Clinton Power Station

Subject: Additional Information Supporting the License Amendment Request to Permit
Up-rated Power Operation at Clinton Power Station

Additional Information Supporting the License Amendment Request to Permit Up-rated Power Operation at Clinton Power Station (Non-Proprietary)

**Figure 5.1a-1
Batch Offload SFP Decay Heat Load**

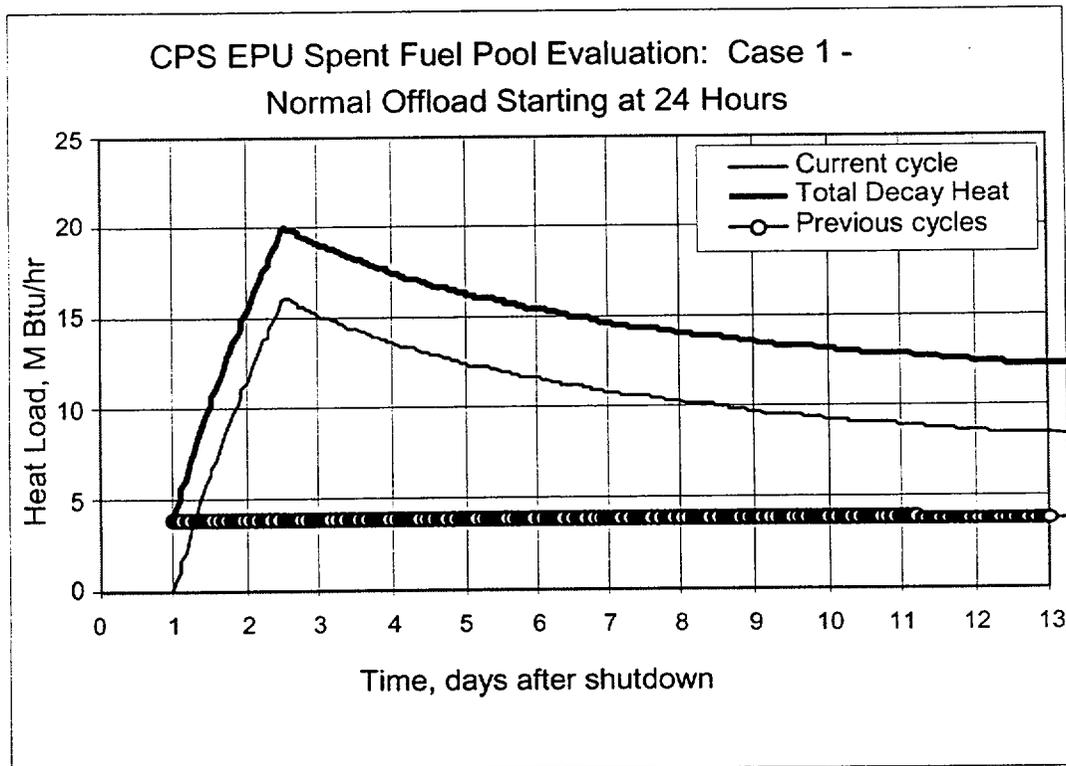
5.1a SFP heat loads and the corresponding peak calculated temperatures during planned (normal) partial and/or full-core offload outages and unplanned (abnormal) full-core offload outages for pre-EPU and EPU conditions. A planned offload is the offload of fuel assemblies to the SFP for any expected (or planned) reason (e.g., refueling outage). An unplanned offload is the offload of fuel assemblies to the SFP due to an unforeseen condition (e.g., unexpected shutdown that includes an offload).

5.1a The following Figures 5.1a-1 through 5.1a-4 show the calculated response of the SFP for partial and full-core offloads for EPU conditions.

Figure 5.1a-3
Batch Offload SFP Temperature

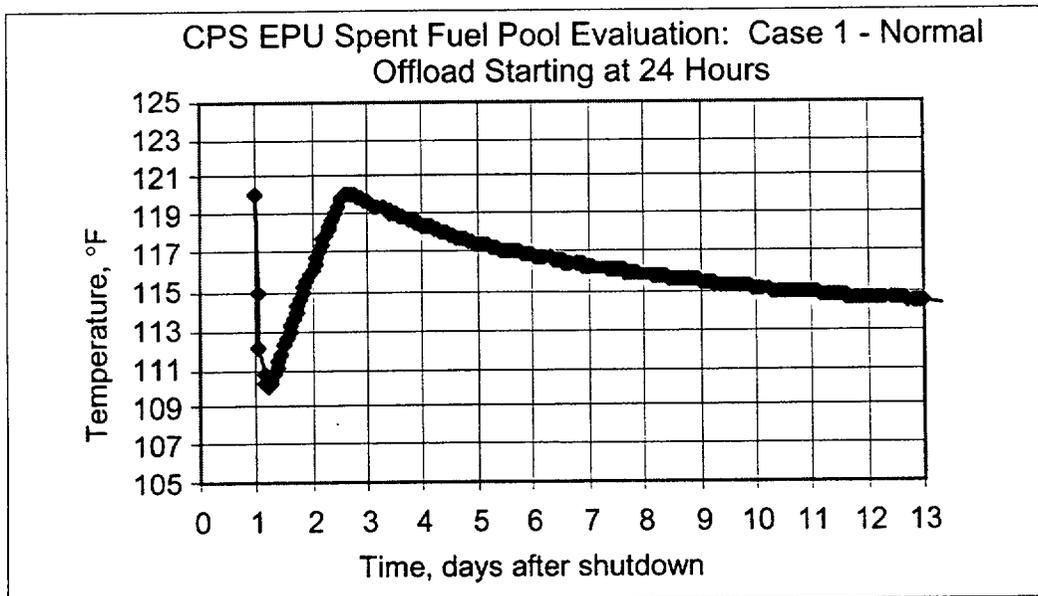
5.1e For the planned refueling outages (with either partial or a full-core offload), if the calculated peak SFP temperature is above 150°F, provide thermal stress analyses to demonstrate that the SFP structure can withstand the new high temperature for the duration of time during which the SFP temperature is above 150°F. Mechanical and Civil Engineering Branch (EMEB) has the primary review responsibility for structural thermal stress analyses.

5.1e As demonstrated in the graphs above (i.e., Figures 5.1a-3 and 5.1a-4), the SFP temperature does not exceed 150°F for the planned refueling outage heat load, for either partial or full-core offload.

**Figure 5.1c-1
Batch Offload SFP Temperature for Accident Condition**

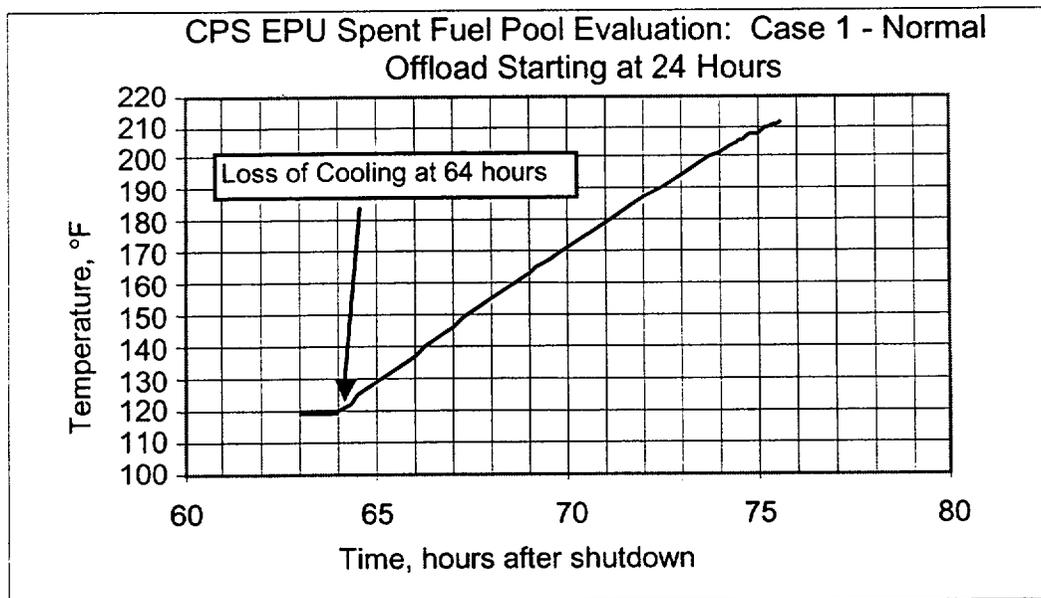
5.1c For the planned refueling outages (with either partial or a full-core offload), discuss how the most severe single failure (e.g., failure of: a FPCC system train, a residual heat removal system train, emergency diesel generator, etc.) has been identified and accounted for in the SFP thermal-hydraulic analyses. (A single failure need not be assumed for the unplanned full-core offload events.)

5.1c The accident conditions are initiated at the peak SFP temperature for partial and full-core offload scenarios, by assuming that the entire FPCCS cooling capacity is lost. The results of the analysis are shown in Figures 5.1c-1 and 5.1c-2.

**Figure 5.1c-2
Full Core Offload SFP Temperature for Accident Condition**

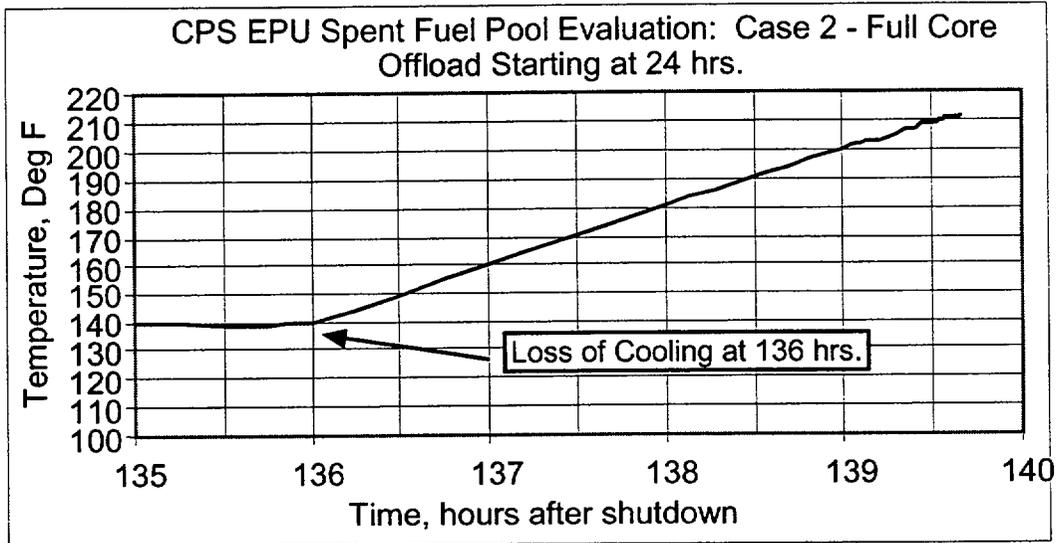
5.4c Information supporting a determination that there is sufficient time for operators to intervene in order to ensure that the temperature limit of 150°F will not be exceeded.

5.4c Based on the graph above for the worst case scenario, (i.e., a full-core offload with a complete loss of SFP cooling starting at the peak SFP temperature of 140°F as described in Figure 5.1c-2), the amount of time for operator action to prevent exceeding 150°F SFP temperature is greater than 30 minutes. Since a system malfunction that would initiate a loss of cooling is annunciated in the Main Control Room, sufficient response time remains for the operators to take actions to mitigate the temperature rise.
